Re: Little Britain Road Service Center (VCP Index # A3-0388-0599)
Revised MW05-8C Investigation Work Plan

MW05-8C INVESTIGATION WORK PLAN

Little Britain Road Service Center

January 2018 (revised February 2018)

FIGURE 2. EXAMPLE BEDROCK MONITORING WELL CONSTRUCTION

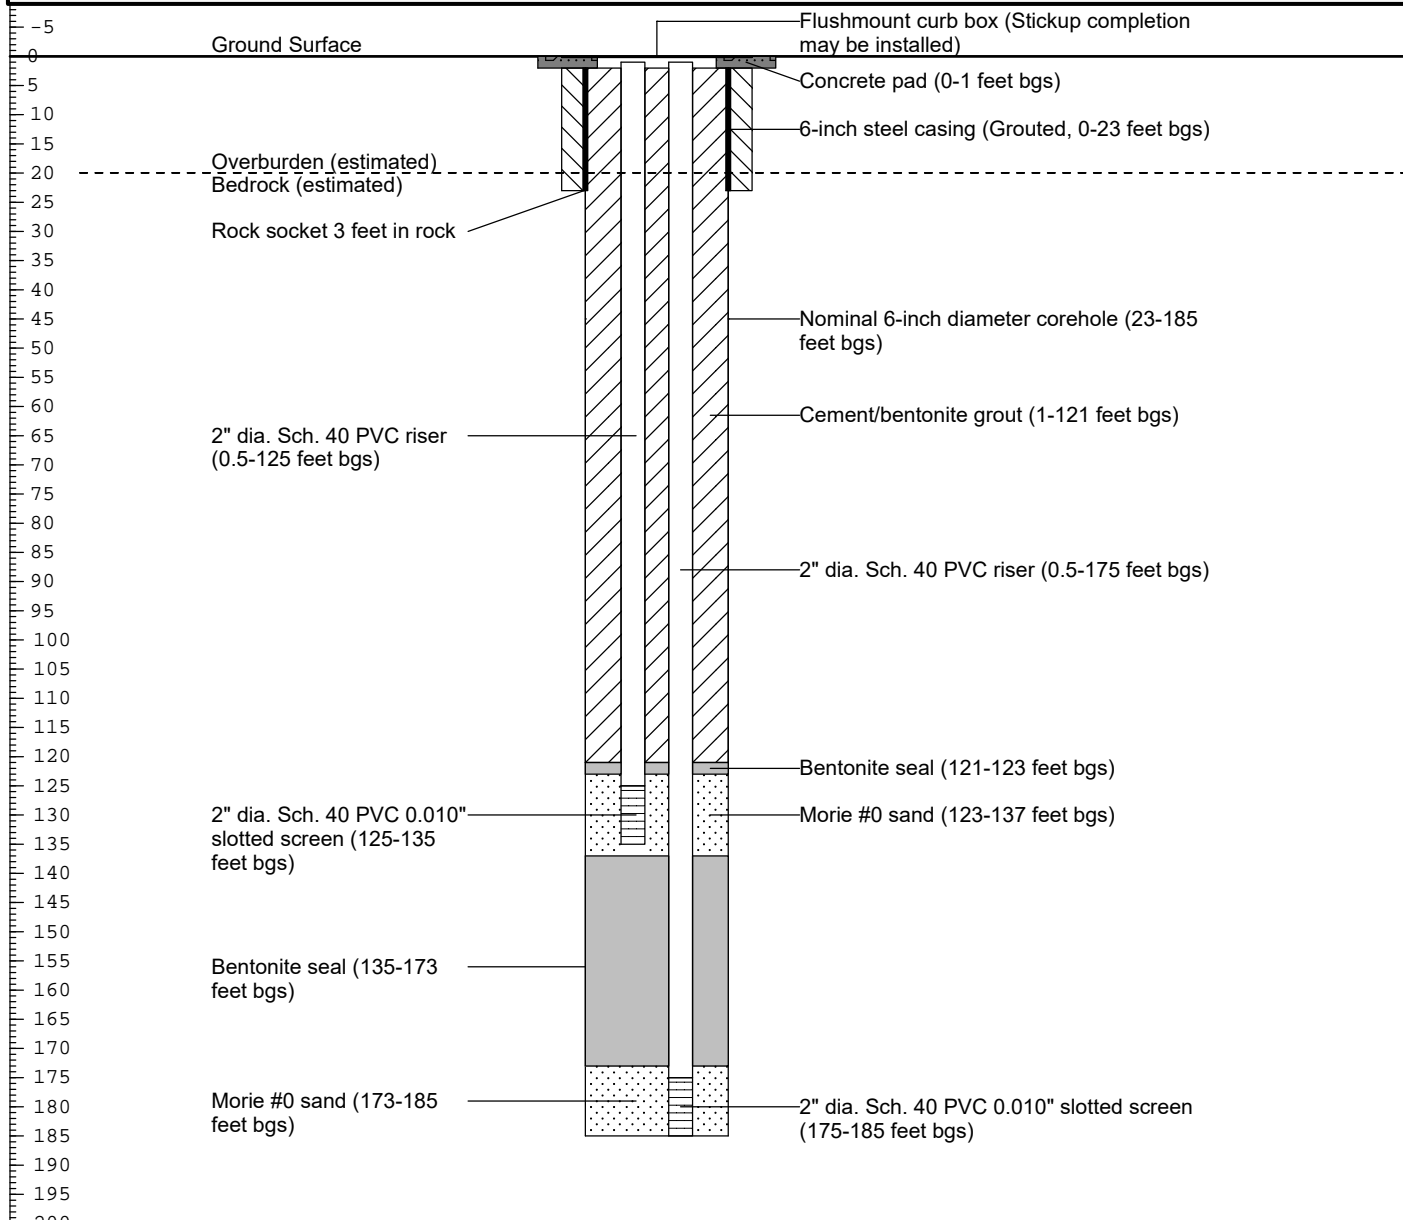
- **Page 5, Section 2.2.1 – A cross-section well design figure should be included in the work plan.**

Response: An example of a typical bedrock monitoring well cluster construction has been included.
